CITY OF ALBUQUERQUE

Re: Sandia Foundation
807 Arno St NE
Traffic Circulation Layout
Engineer's/Architect's Stamp **XX-XX-XX** (J14D181)

Based upon the information provided in your submittal received XX-XX-16, the above referenced plan cannot be approved for Building Permit until the following comments are addressed:

TRACT 2-A (1.3642 AC.)
 LANDS OF SANDIA FOUNDATION
 807 ARNO ST., NE. ABOQ NM 87102
 TRAFFIC CIRCULATION LAYOUT
 GRADING / DRAINAGE

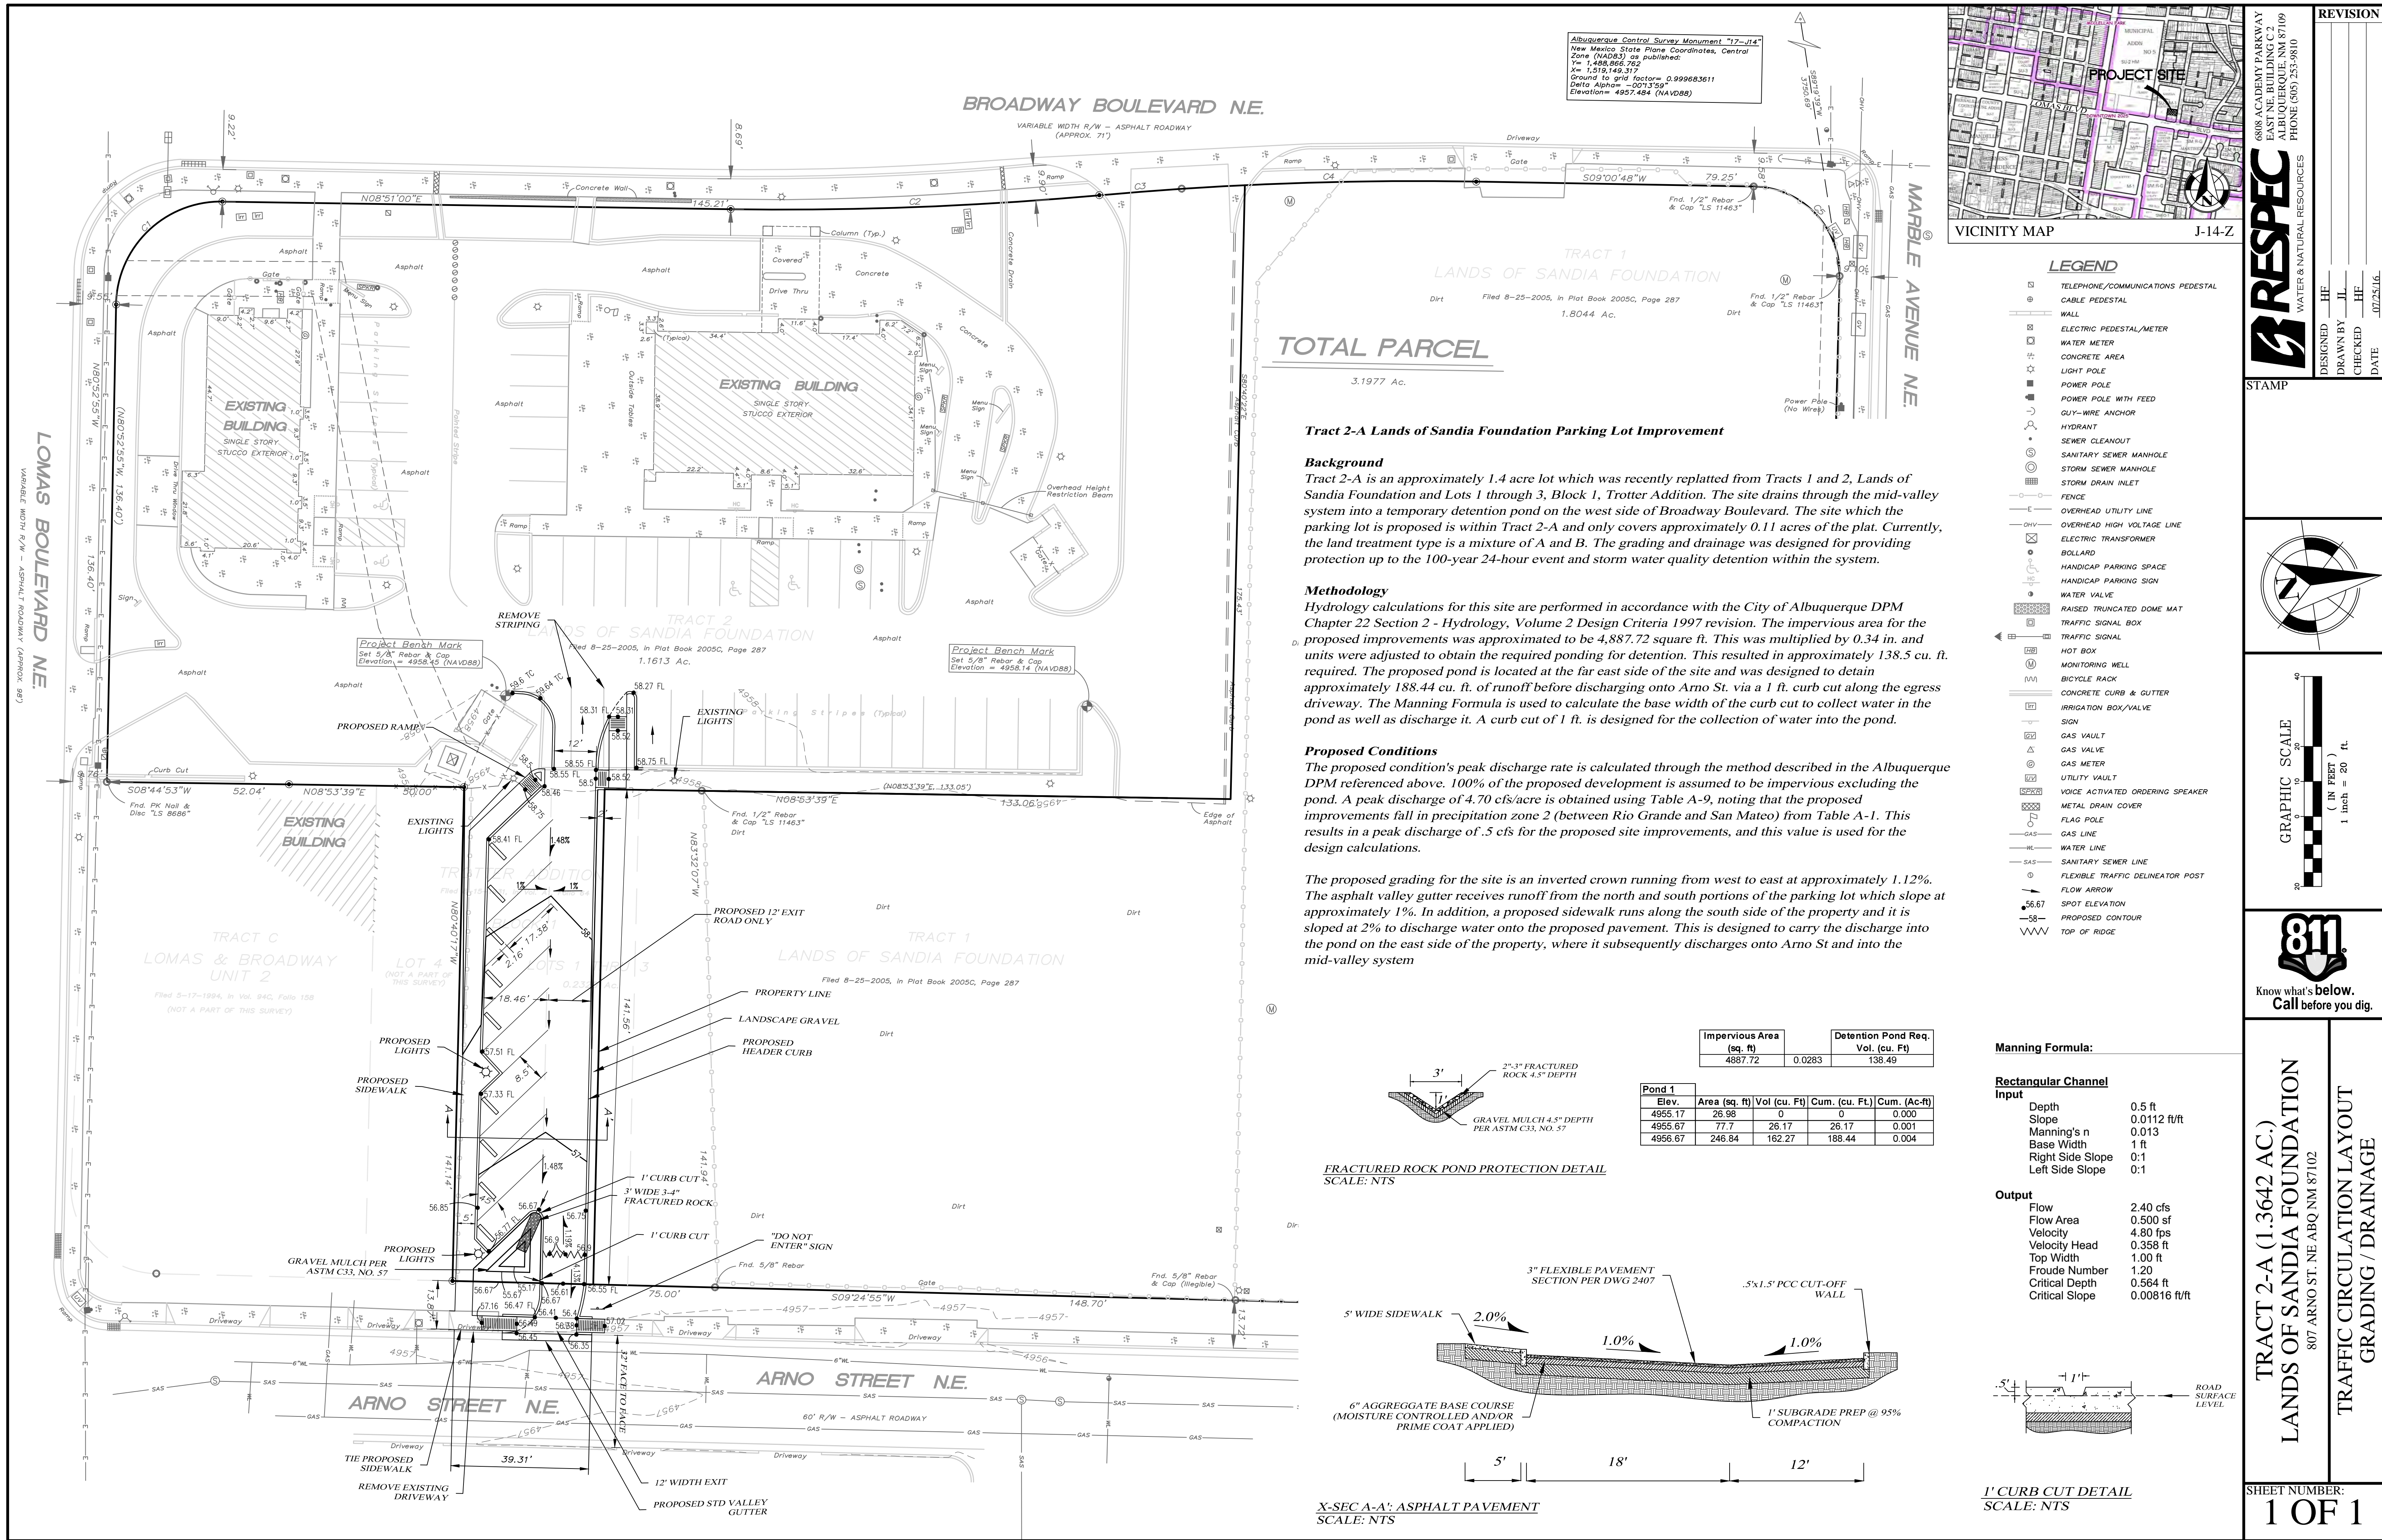
1. Show all drive aisle widths and radii of end islands
2. One-way vehicular paths require pavement directional signage and a posted **"Do Not Enter"** sign at the point of egress. Please show detail and location of posted signs.
3. Please specify the City Standard Drawing Number when applicable.
4. Unused curb cuts must be replaced with sidewalk and curb & gutter. A build note must be provided referring to the appropriate City Standard drawing.
5. A gutter at the East drive way is not necessary unless required by Hydrology.
6. Please include two copies of the traffic circulation layout at the next submittal.
